<b>DOCKETED</b>	
<b>Docket Number:</b>	19-BSTD-03
<b>Project Title:</b>	2022 Energy Code Pre-Rulemaking
<b>TN #:</b>	237093
<b>Document Title:</b>	Southern California Gas Company Comments - SoCalGas Comments on the 2022 Energy Code Pre-Rulemaking Express Terms
<b>Description:</b>	N/A
<b>Filer:</b>	System
<b>Organization:</b>	Southern California Gas Company
<b>Submitter Role:</b>	Public
<b>Submission Date:</b>	3/9/2021 4:54:01 PM
<b>Docketed Date:</b>	3/9/2021

**SoCalGas Comments on the 2022 Energy Code Pre-Rulemaking  
Express Terms**

**Subject: Comments on the Pre-Rulemaking Express Terms for the 2022 Update to the Energy Code**

**Figure 6. Final energy demand in buildings in 2020, and in 2045 across the three scenarios**

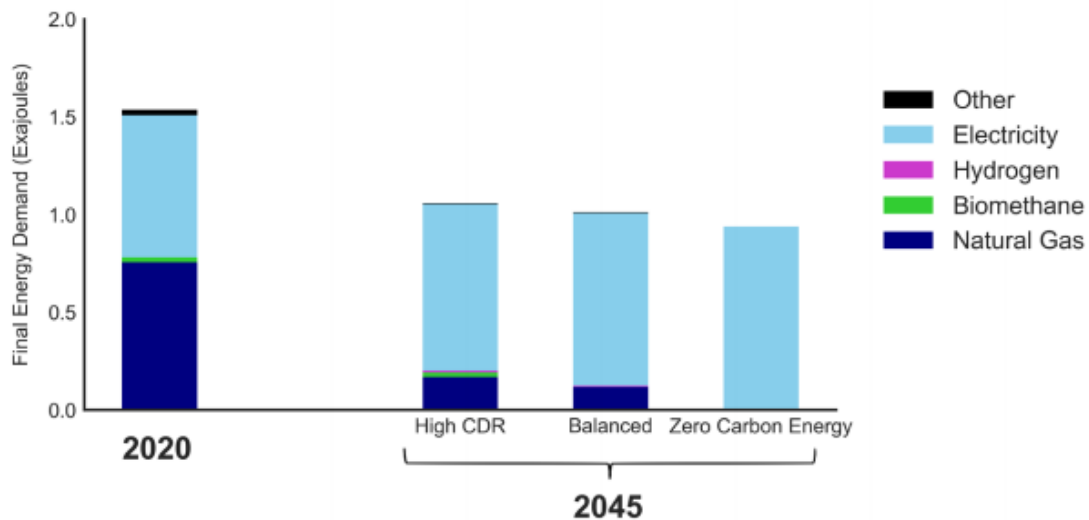
and half from electricity as shown in Figure 6 (below) from E3’s Pathways Report.<sup>8</sup> This is not to suggest or urge adherence to the status quo. But rather to express the need for thorough analysis and development of future decarbonization pathways based on diverse energy sources, and a realistic publicly vetted cost and rate analysis.

**Figure 41: Monthly Energy Bills (Electricity Plus Natural Gas) for a New Mixed-Fuel Home and a New All-Electric Home in a Hot Climate Zone in Three IOU Service Territories**

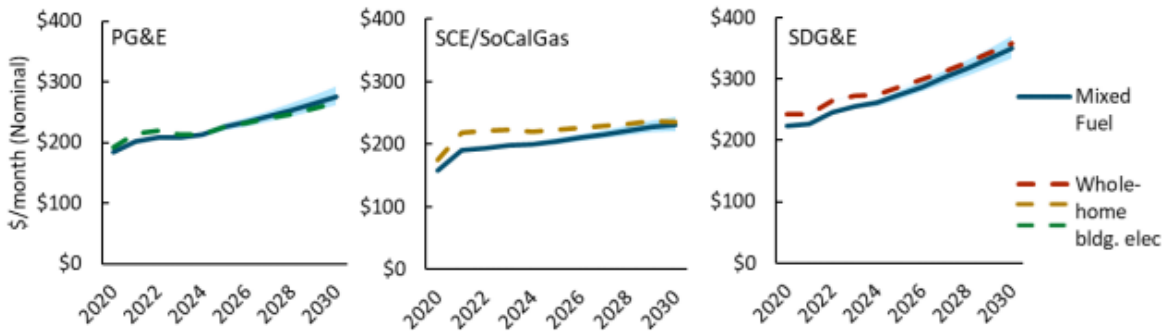
Further, Figure 41 (below) from the CPUC’s Report presented at the 2021 CPUC Energy Rate and Costs En Banc shows that energy costs for mixed-fuel and all-electric homes are similar over the decade and in SoCalGas and SCE territory, mixed fuel homes pay less on average for their monthly utility bill.<sup>11</sup> However, trends in gas and electric rates, as well as policy decisions or incentives, can ultimately determine whether all-electric customers see net bill savings or costs. The customer cost-effectiveness of all-electric new homes represents an important policy consideration for achieving GHG emissions reductions in buildings.<sup>12</sup>

**Figure 3.** Carbon Intensity Heat Map of California’s Electric Grid from 2010-2019<sup>14</sup>

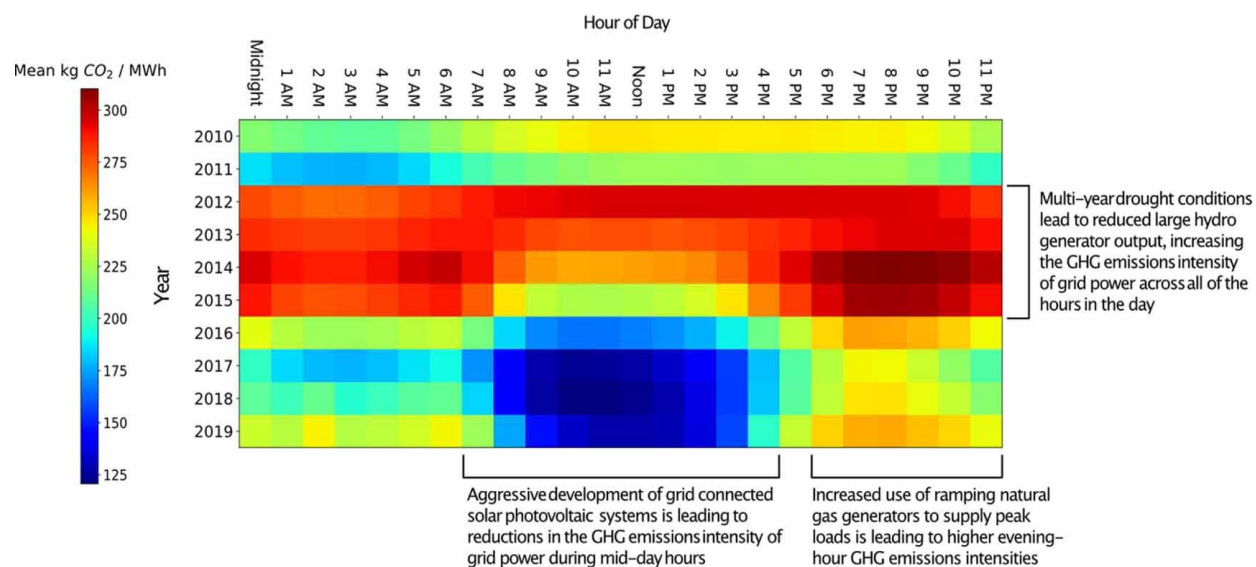
A recent study published by the University of California, Los Angeles (UCLA study) evaluated the hourly variations in the intensity of residential household’s natural gas use within a low-income portion of SoCalGas’ service territory.<sup>13</sup> Researchers found that the aggressive electrification of residential end-use appliances has the potential to exacerbate daily peak electricity demand, increase total household expenditures on energy, and, in the absence of a fully decarbonized electrical grid, will likely result in limited GHG emissions abatement benefits. Using templates based on temporal usage data for specific communities can help to distinguish low-income households from wealthier households within the same climate zone. This will also ensure GHG emissions reductions are occurring given the time dependent nature of the carbon intensity of the electric grid (see Figure 3 below).

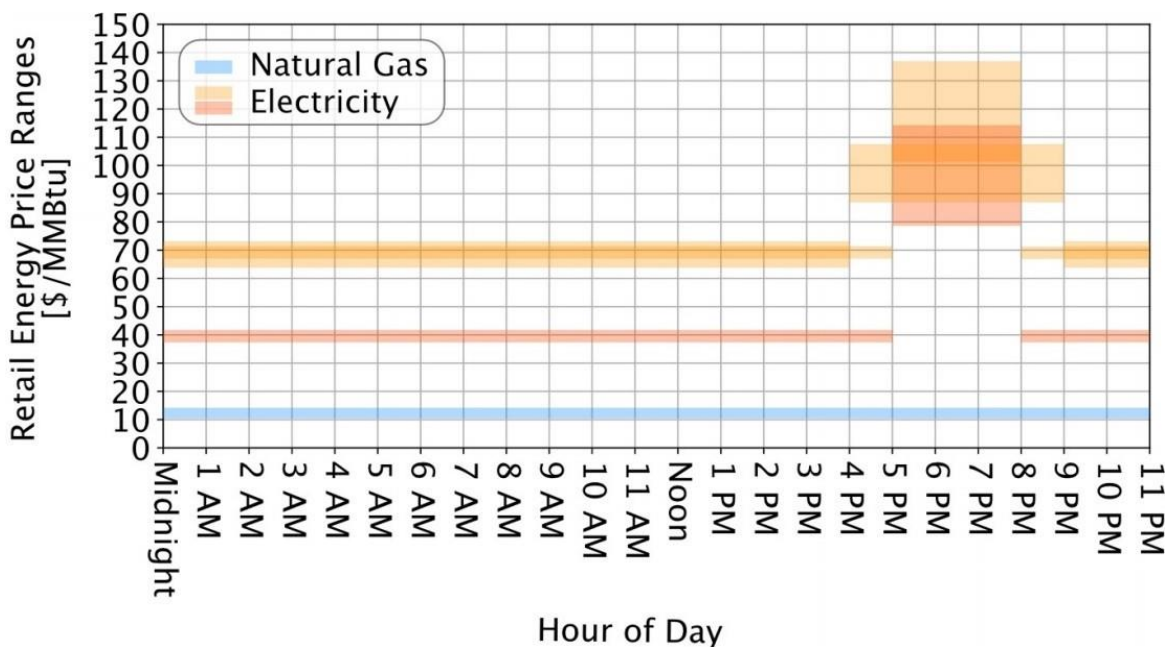
[cannot] afford their bills.”<sup>15</sup> These higher energy burdens are not only because of lower incomes, but also because of energy inefficiencies in the home and the time-of-use of energy. For most households, there is very little flexibility in the time-of-use of their energy consumption. Most households use their appliances in the early morning hours when preparing to depart from home and in the evening hours when returning home. Under the existing electricity rate structures, switching from a low energy cost appliance (gas appliance) to a higher energy cost appliance (electric heat pump) will increase a household’s expenditure on energy. This is because a household’s time-of-use coincides with periods of peak-electricity demand when electricity rates are up to four times or more than gas rates on an energy equivalent basis. In fact, Figure 4<sup>16</sup> (below) from the UCLA study shows that “the price premium for electrical energy can grow to a factor of 12 times during peak hours (4PM-9PM).”<sup>17</sup>
